SUBJECT: PCT STRAD BAY ROOF & HUSKY MAINTENANCE TOWER ROOF
REPLACEMENTS
PROJECT NO. 201191.01 & 201204.01
CONTRACT NO. 072112

ADDENDUM NUMBER 02

1 PCT STRAD BAY - ROOF DEMOLITION PLAN
 AD1.00 1" = 10'-0"
 NORTH

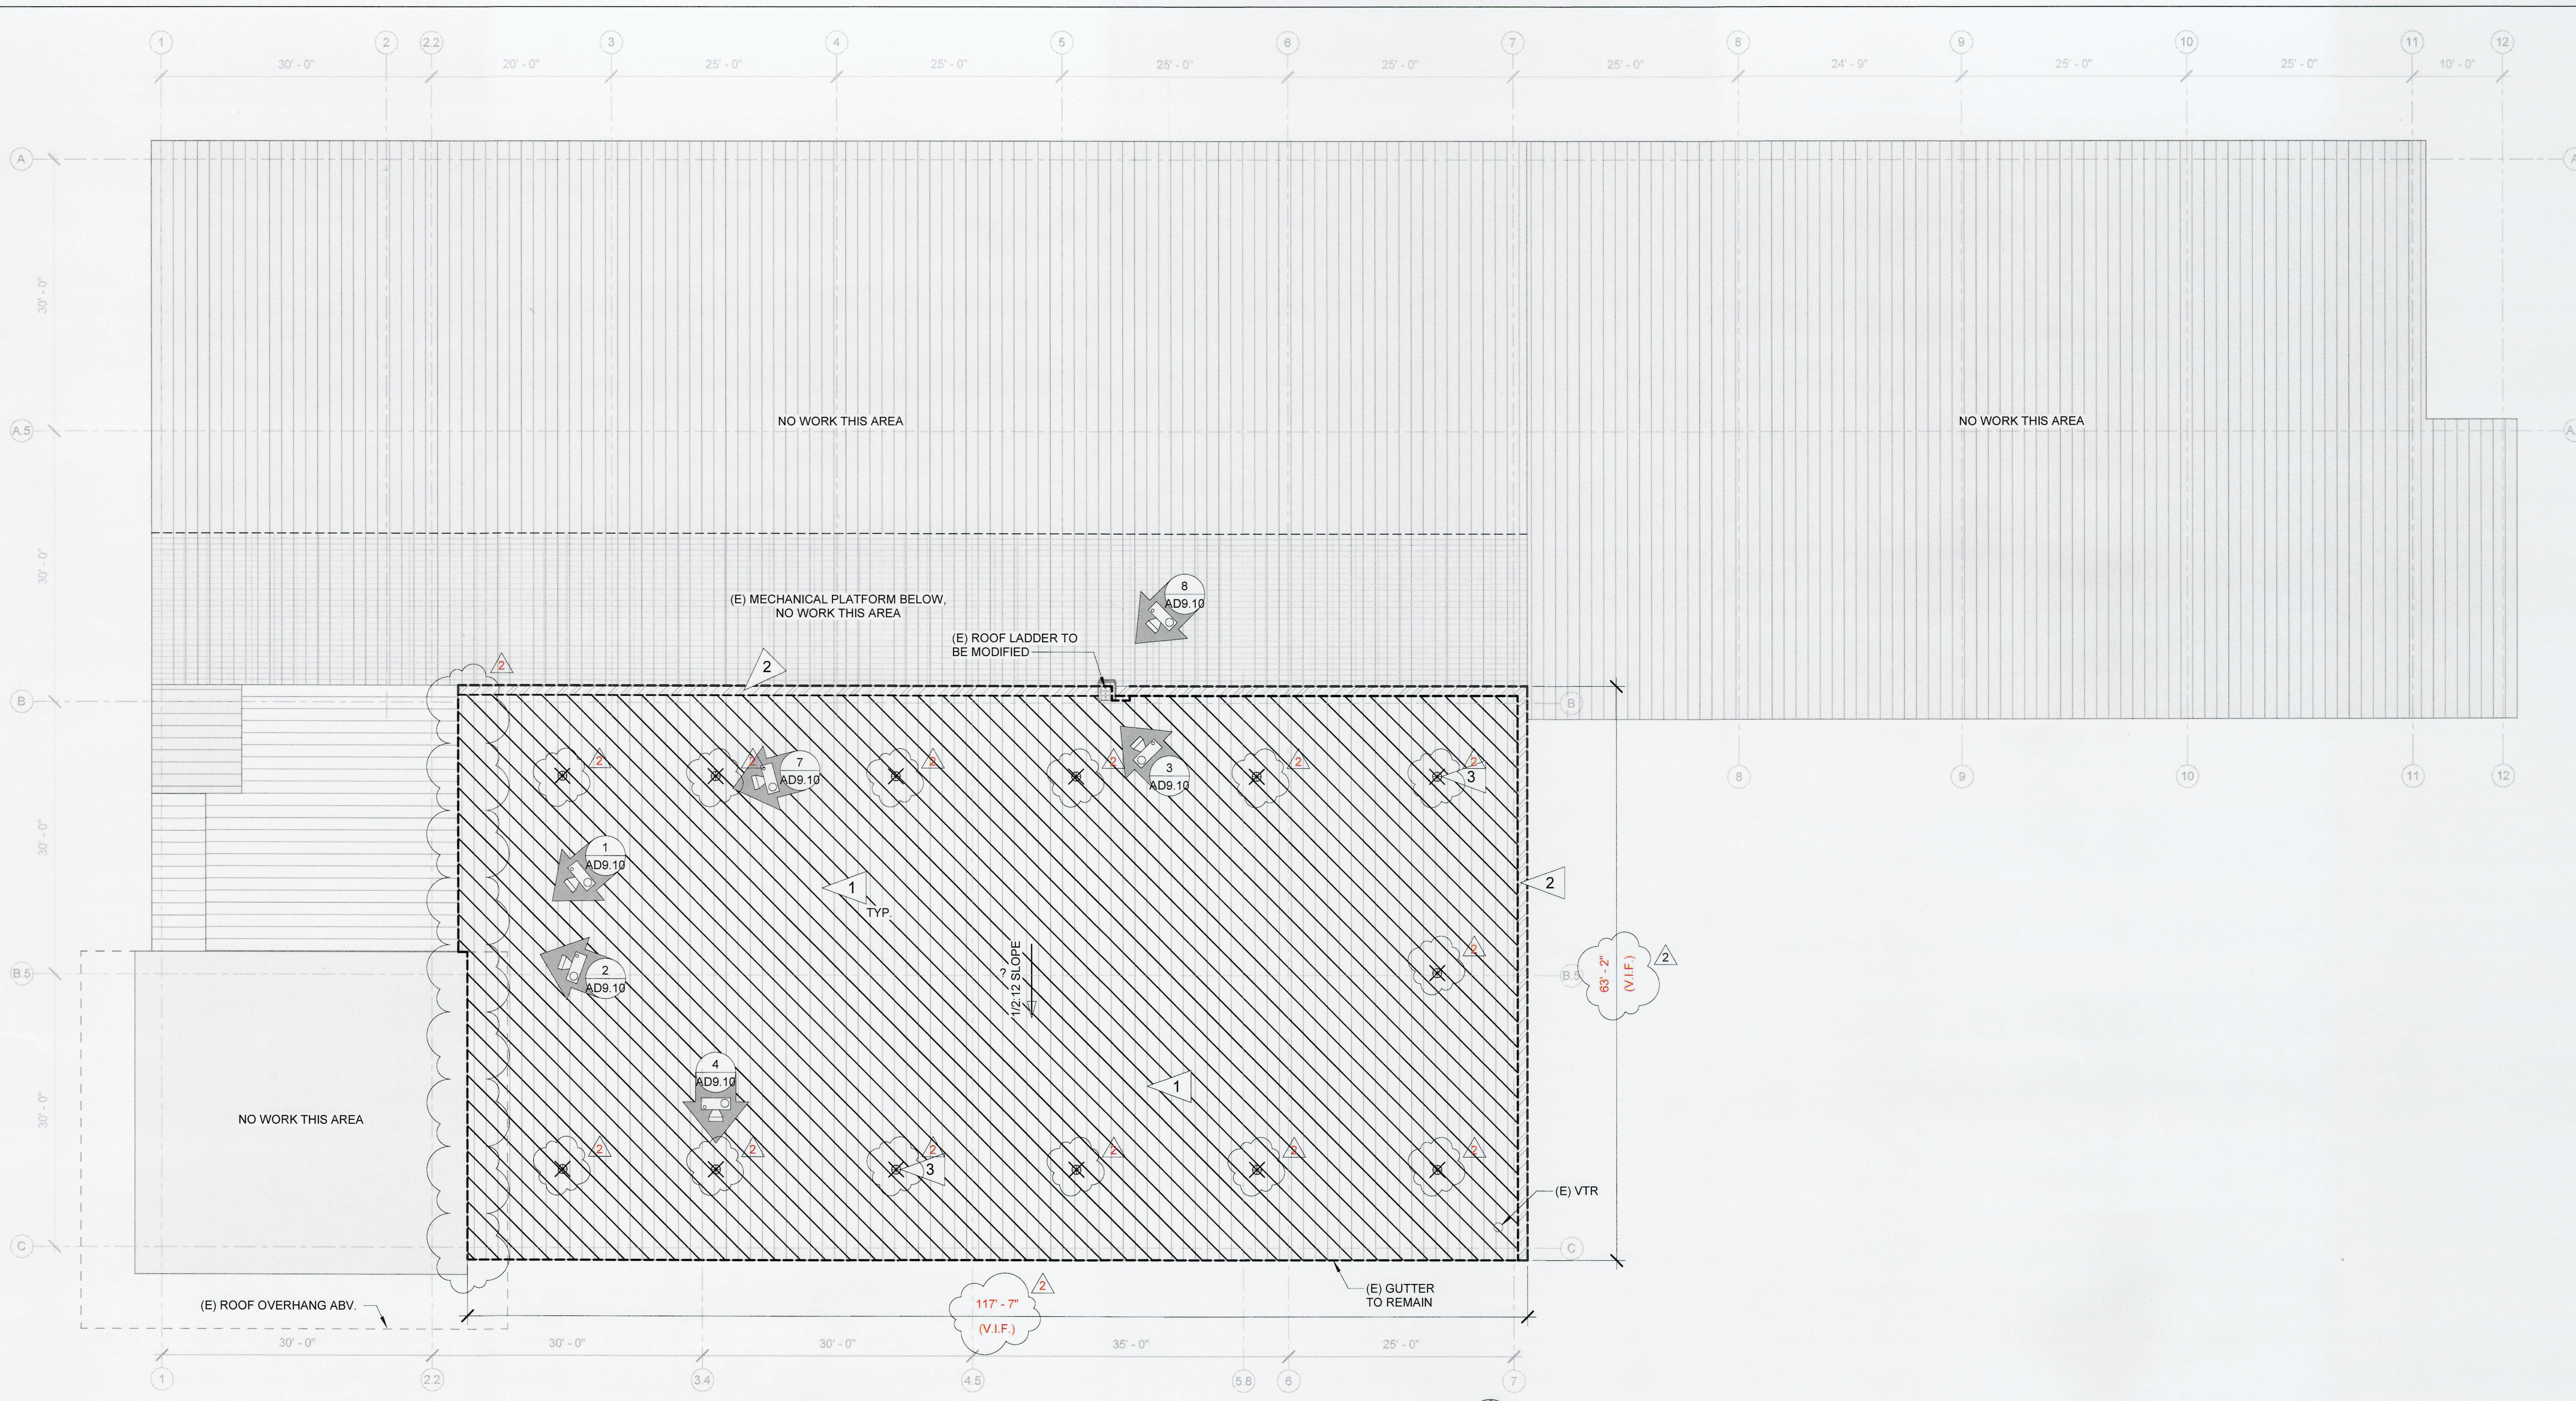
DEMOLITION KEYNOTES		DRAWING LEGEND	
1	DEMOLISH (E) ACRYLIC COATED, STANDING SEAM METAL ROOF PANELS 18" WIDE	○	(E) VENT THROUGH ROOF TO REMAIN (VTR)
2	DEMOLISH (E) FLASHING, TRIM, AND/OR VTR BOOT FLASHING. (E) GUTTER TO REMAIN	⊗	(E) FALL PROTECTION ANCHOR TO BE DEMOLISHED
3	DEMOLISH (E) FALL PROTECTION ANCHORS, 13 QTY.

1
A1.10
1/8" = 1'-0"

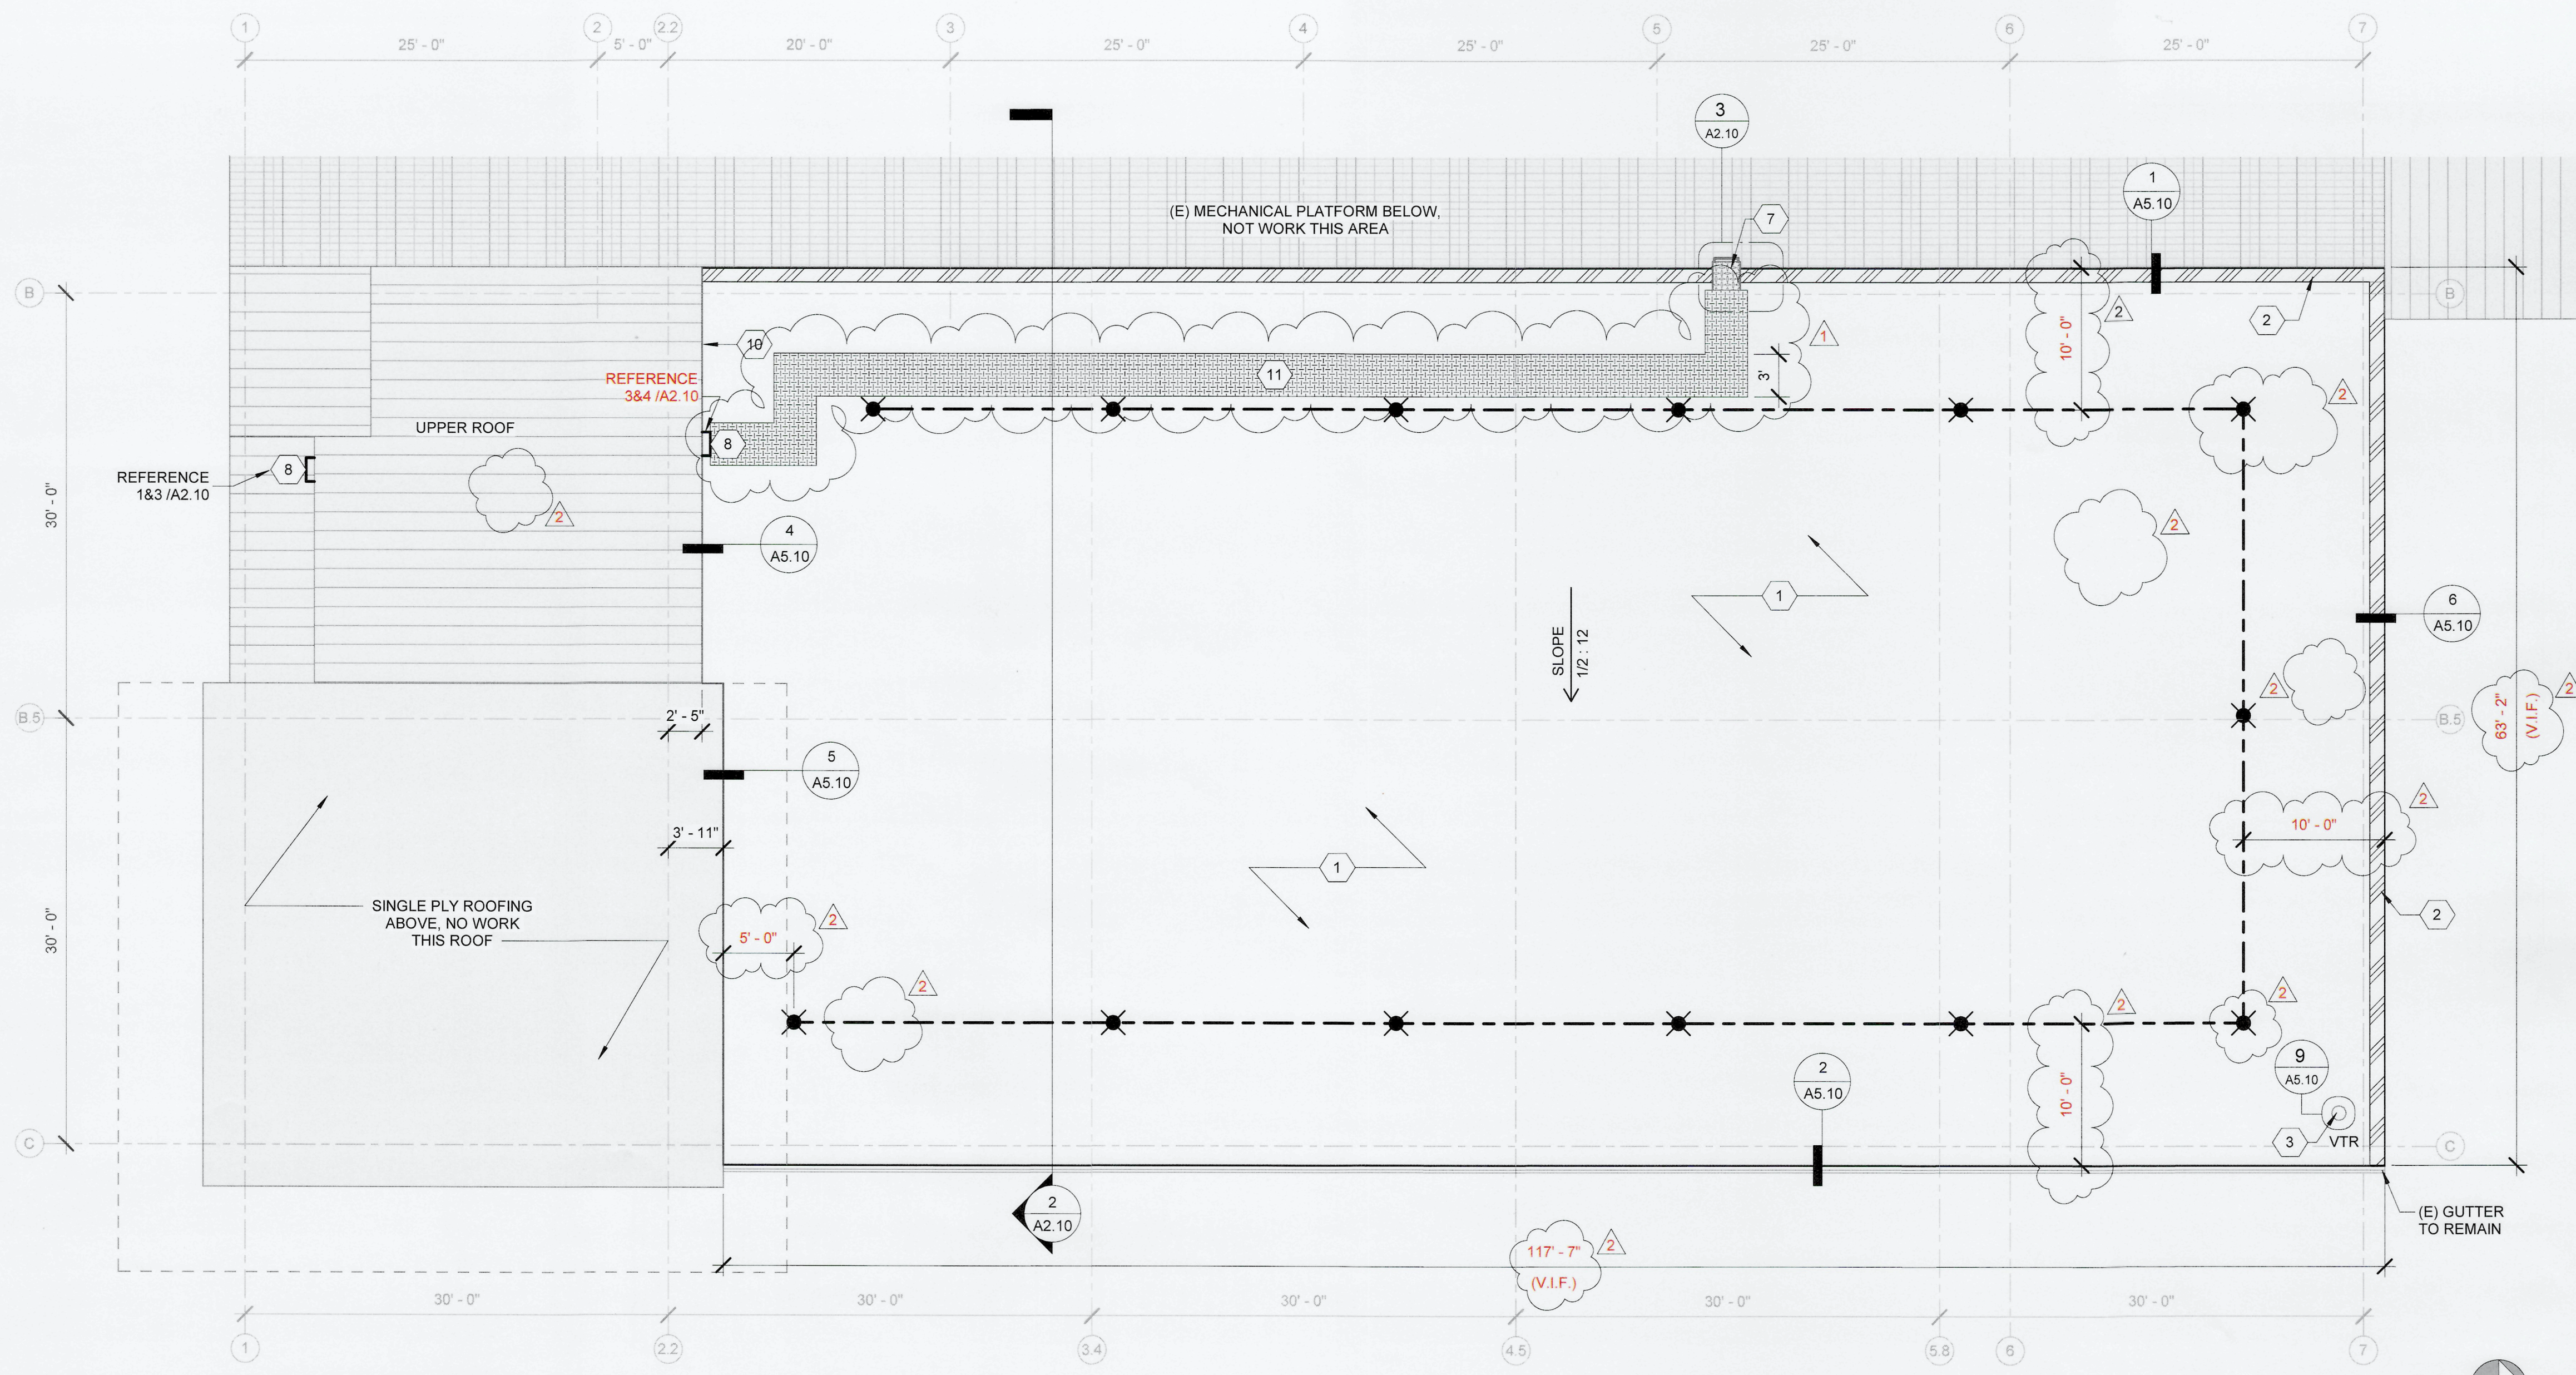
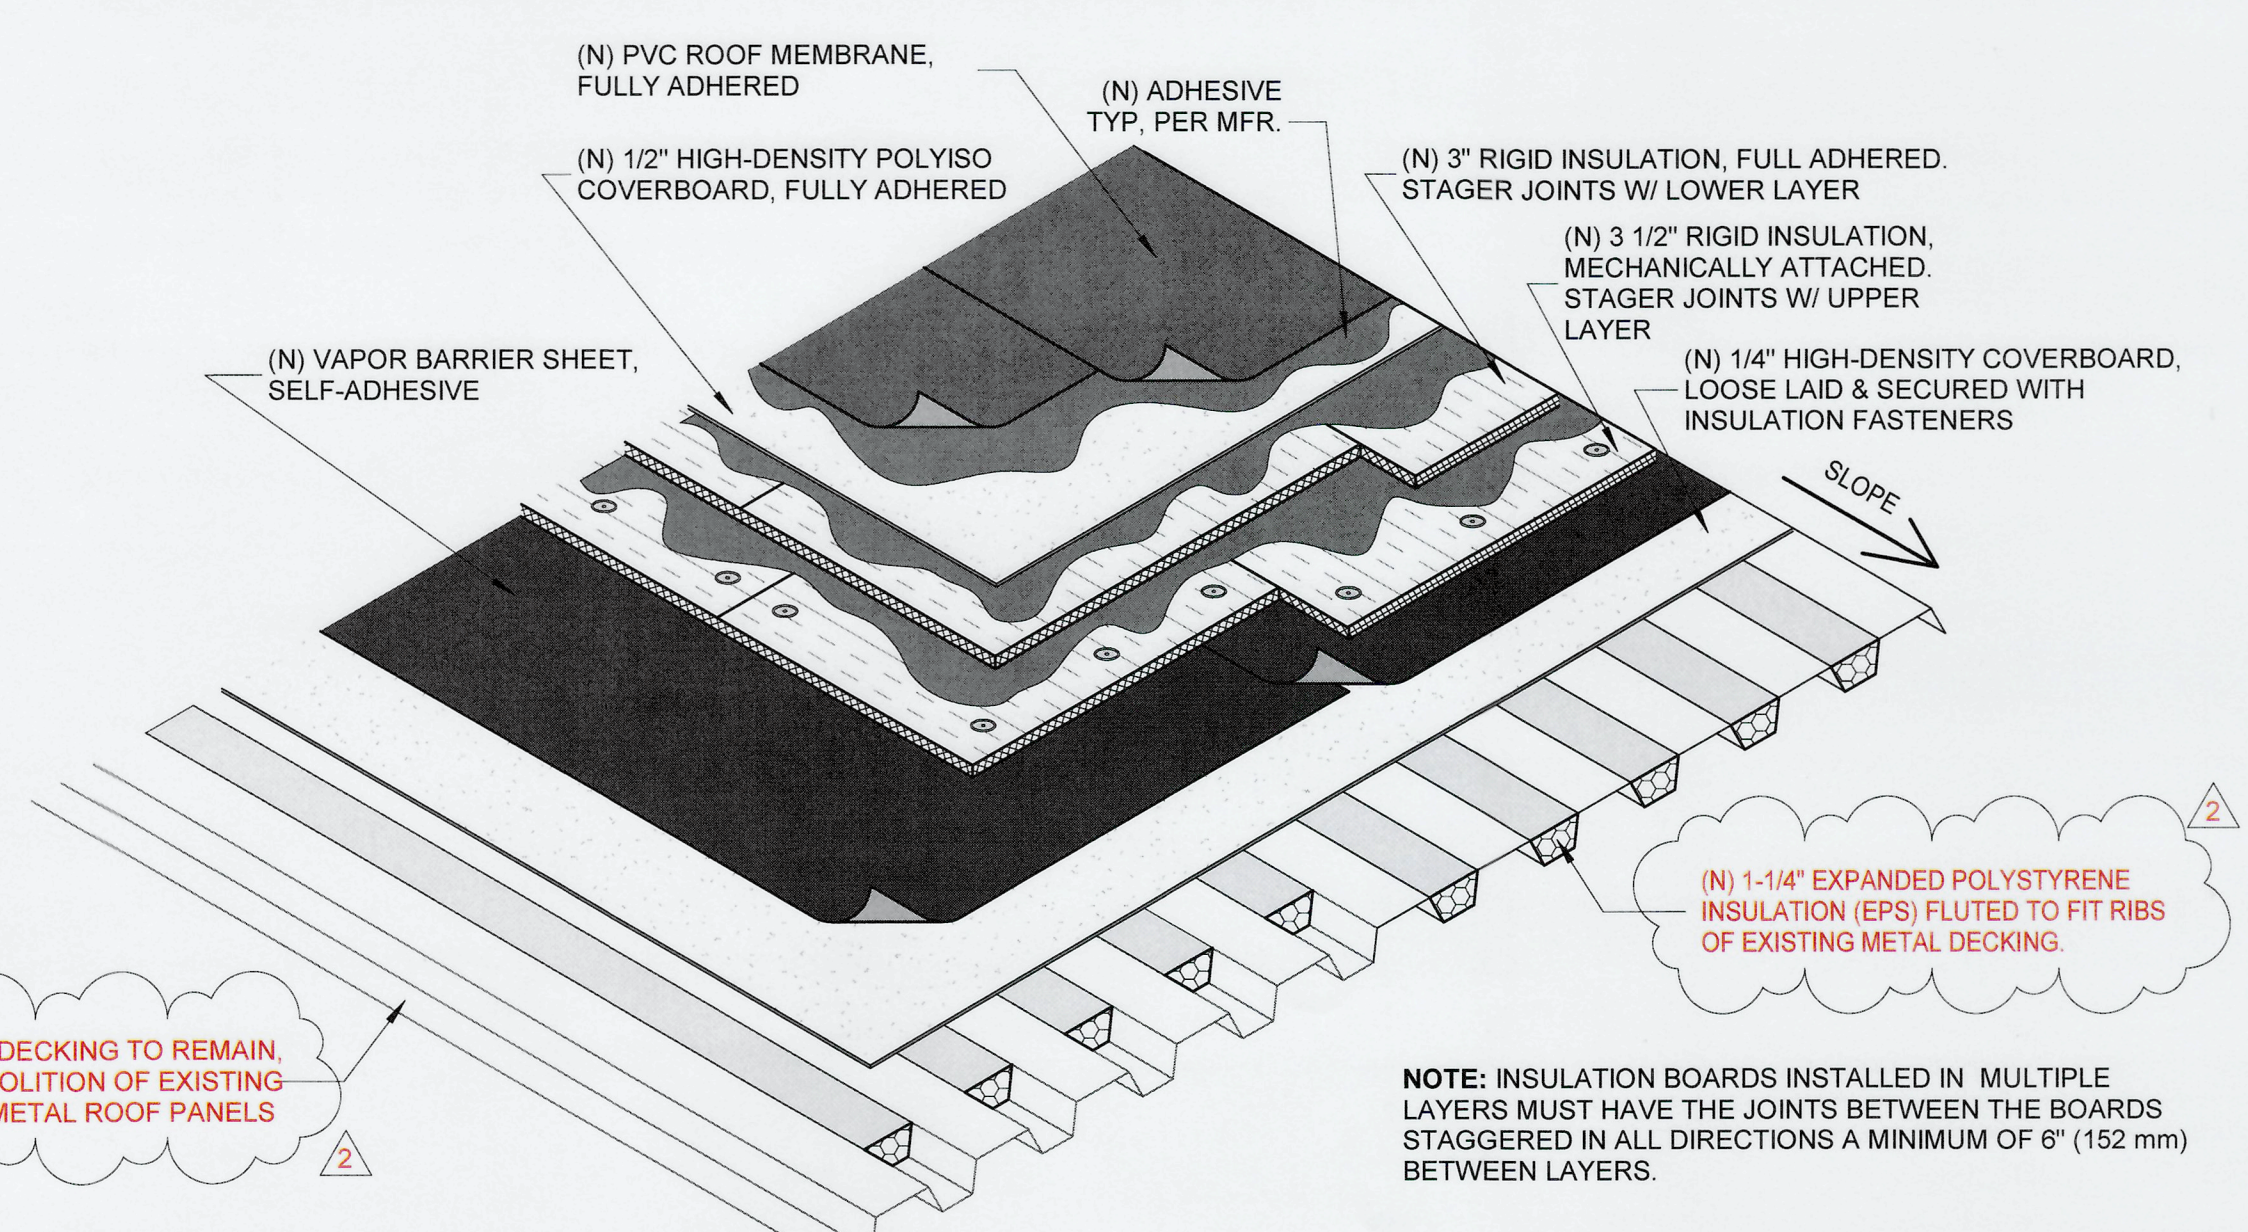
FALL PROTECTION SYSTEM NOTES:

CONTRACTOR SHALL DESIGN AND PROVIDE A COMPLETE AND ENGINEERED FALL PROTECTION SYSTEM THAT PROVIDES FULL COVERAGE FOR THE ROOF AREA TO RECEIVE NEW PVC ROOFING.

FALL PROTECTION SYSTEMS HAVE BEEN DESIGNATED AS A DEFERRED SUBMITTAL FOR THIS PROJECT. THE CONTRACTOR IS RESPONSIBLE FOR THE PREPARATION AND SUBMISSION OF ALL DEFERRED SUBMITTALS TO THE AHJ. DEFERRED SUBMITTALS SHALL BE SUBMITTED BY A REGISTERED DESIGN PROFESSIONAL OTHER THAN THE ARCHITECT OF RECORD. THE ARCHITECT OF RECORD ASSUMES NO RESPONSIBILITY FOR THE DEFERRED SUBMITTALS.

DEFERRED SUBMITTALS SHALL INCLUDE SHOP DRAWINGS, DETAILS, AND STRUCTURAL CALCULATIONS DESIGNED AND STAMPED BY A LICENSED STRUCTURAL ENGINEER IN THE STATE OF WASHINGTON (HIRED BY THE CONTRACTOR). CALCULATIONS SHALL ADDRESS ALL APPLICABLE LOADS IDENTIFIED IN THE IBC, INCLUDING ANCHORAGE TO THE EXISTING BUILDING STRUCTURE. CONTRACTOR SHALL MAKE MODIFICATIONS TO THE SYSTEM AS NEEDED TO COMPLY WITH THE REQUIREMENTS OF THE AHJ.

FALL PROTECTION ANCHORS SHOWN ON THE DRAWINGS ILLUSTRATE THE MINIMUM BASIS OF DESIGN. FINAL LAYOUT INCLUDING ALL COMPONENTS AND ACCESSORIES IS THE RESPONSIBILITY OF THE SYSTEM DESIGNER.
